**In the matter of** Variation 1 to the Proposed Waimakariri District Plan

**Council Officer's Final Right of Reply on Variation 1**

*Geographical scope of testing*

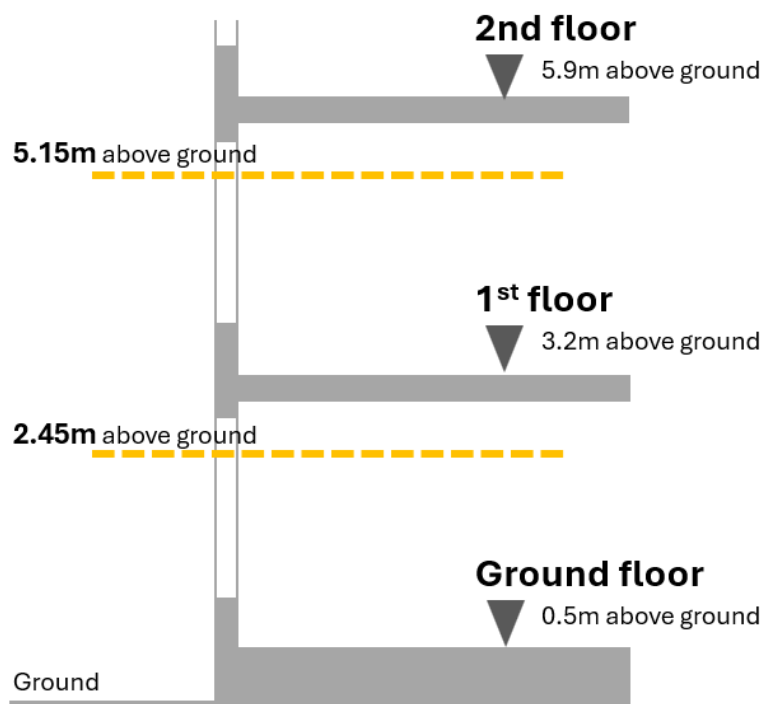
10. The study investigates attached dwellings on each residential lot in the district. Testing on all actual residential lots throughout Rangiora, Woodend/Pegasus, and Kaiapoi ensures fully comprehensive site-specific testing through the district.
